**STATE OF HAWAII  
DEPARTMENT OF TRANSPORTATION  
AIRPORTS**

**ADDENDUM NO. 6  
FOR  
UST/AST REMOVALS AND REPLACEMENTS  
DANIEL K. INOUE INTERNATIONAL AIRPORT  
HONOLULU, OAHU, HAWAII  
PROJECT NO. AO1105-12**

**February 27, 2026**

1 MAINTENANCE BASEYARD - SCHEMATIC DIAGRAM  
M-502 NOT TO SCALE

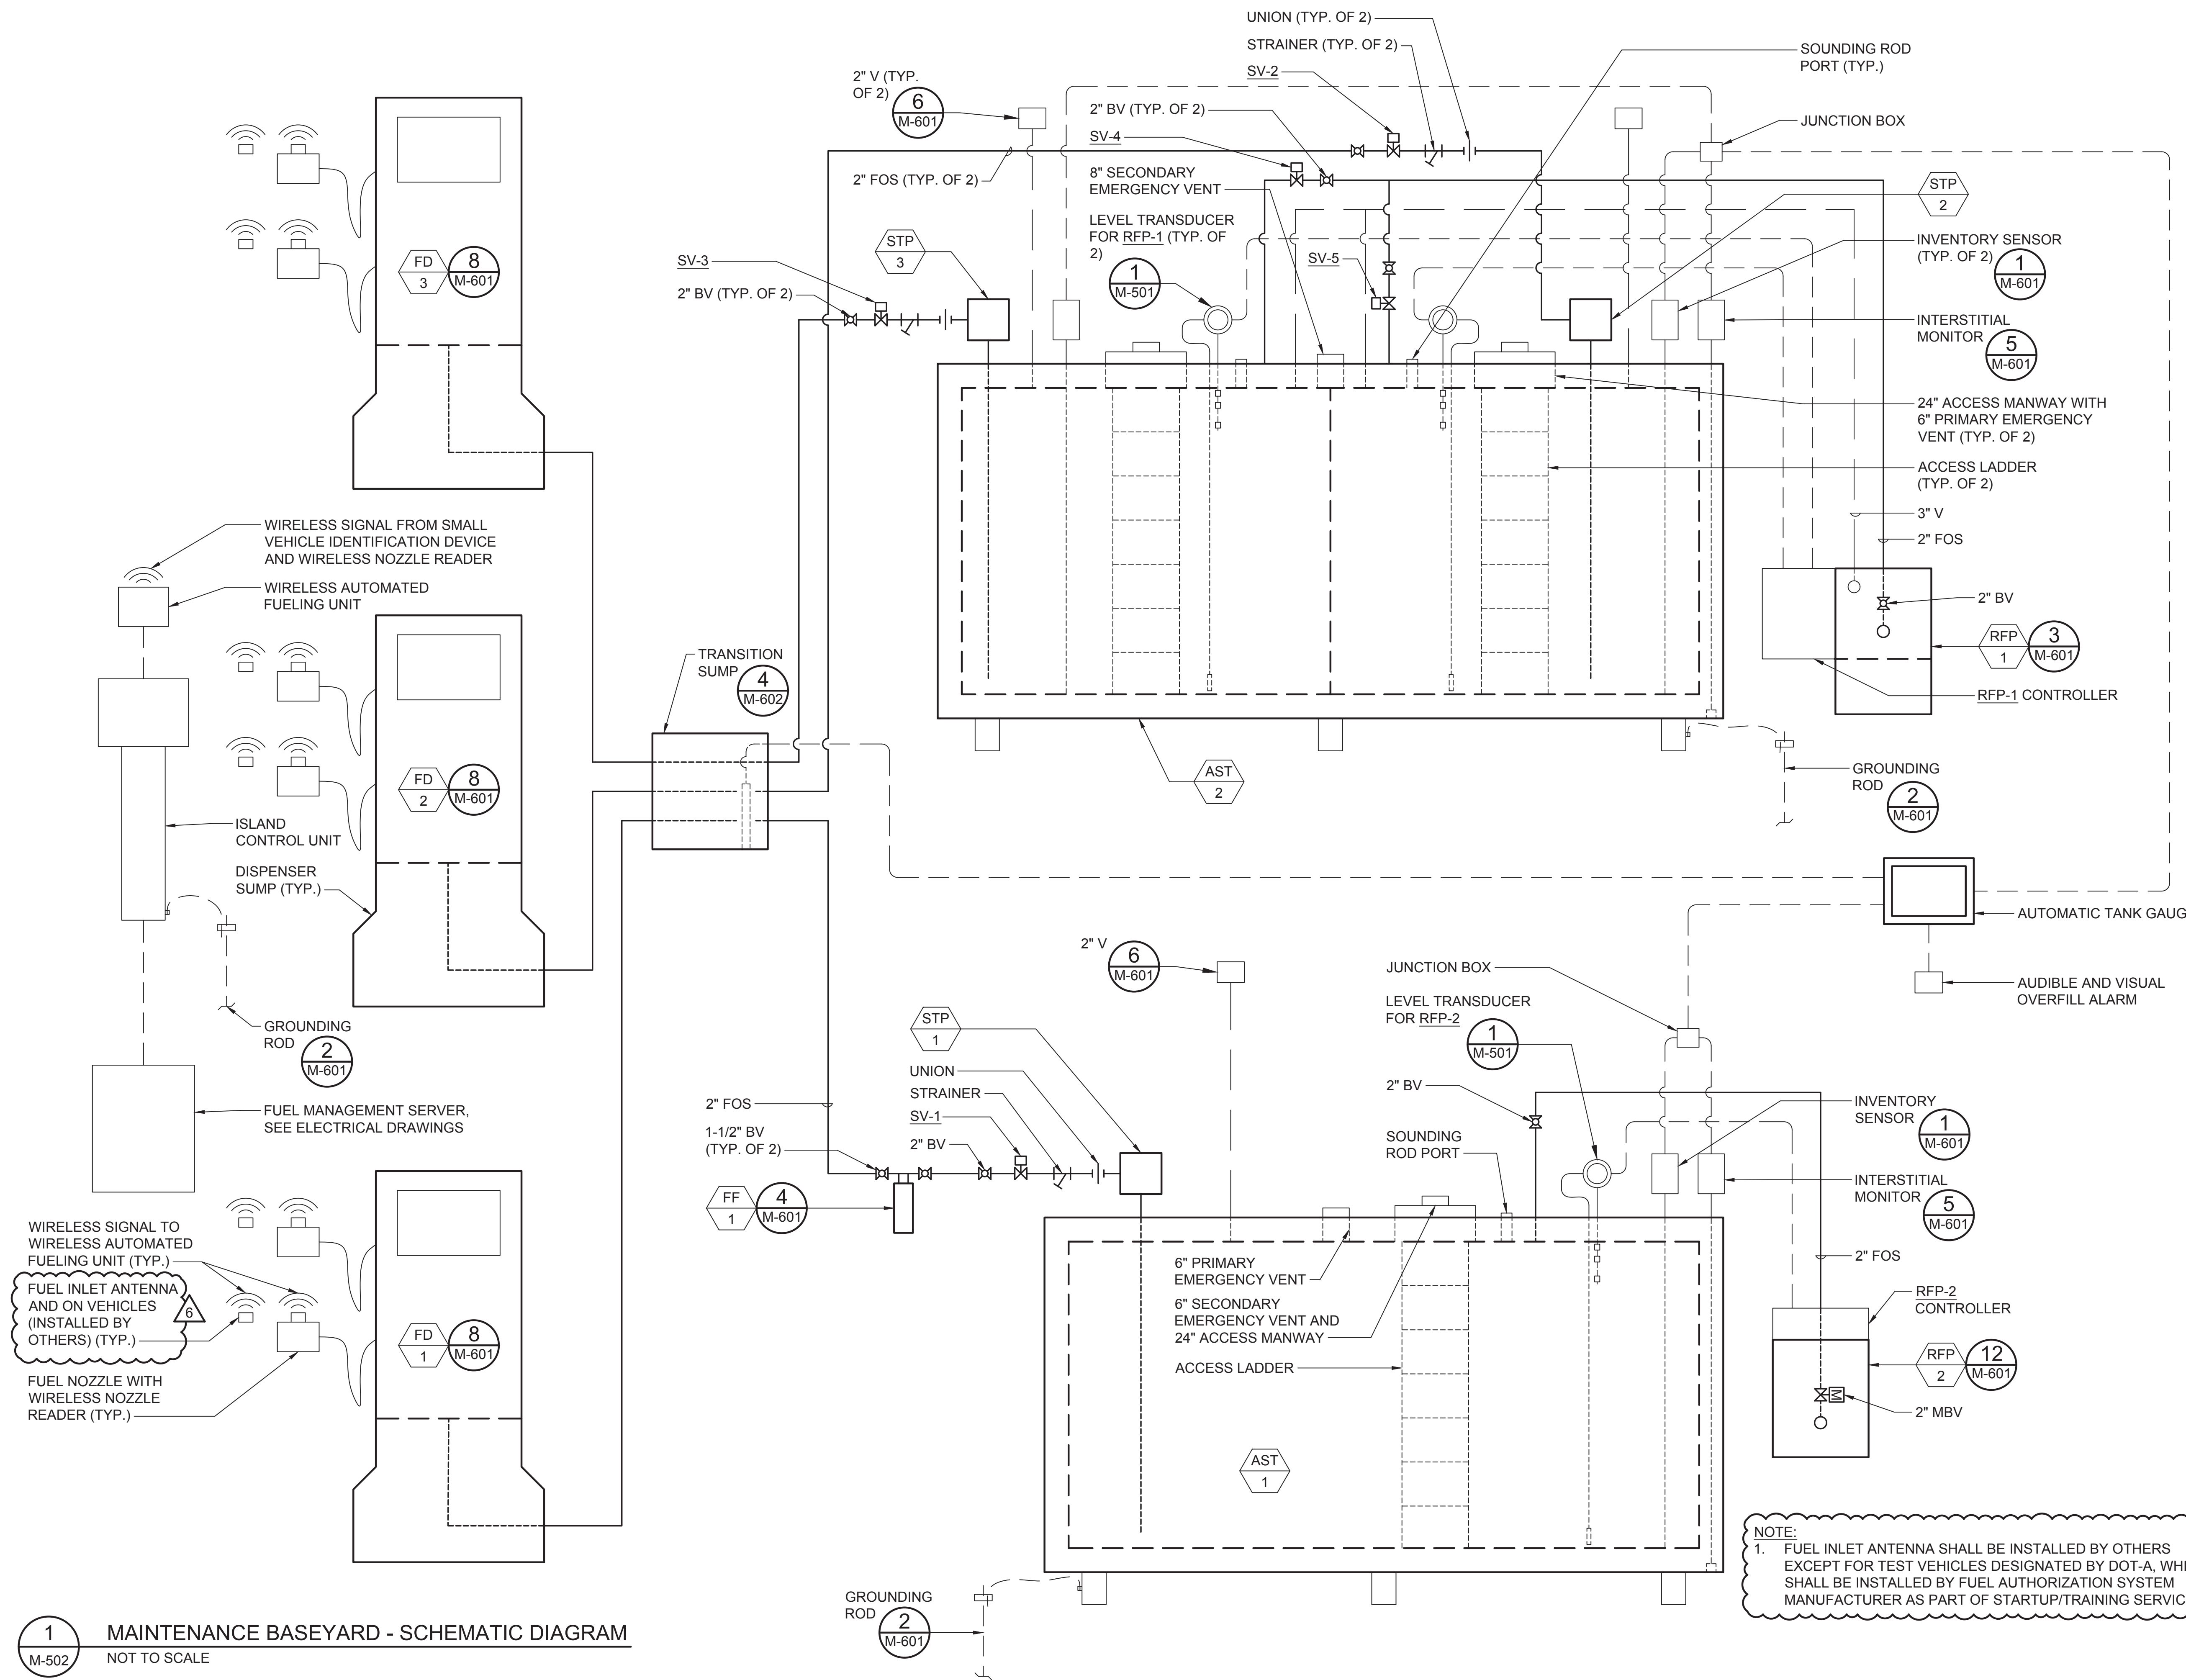
**5. Sheet M-502, Detail 1 illustrates a "Small Vehicle Identification Device". Are the State vehicle mechanics going to be installing these devices in their vehicles? The contractor should not be responsible for installing any devices in State vehicles.**

Installation of vehicle RFID devices shall be performed as part of fuel authorization system manufacturer's startup and training for a vehicle test group under this contract and, for other fleet vehicles, under a separate contract. Refer to Addendum No. 6 Drawing M-502 and Addendum No. 6 SECTION 15193, paragraph 2.14.C.4.
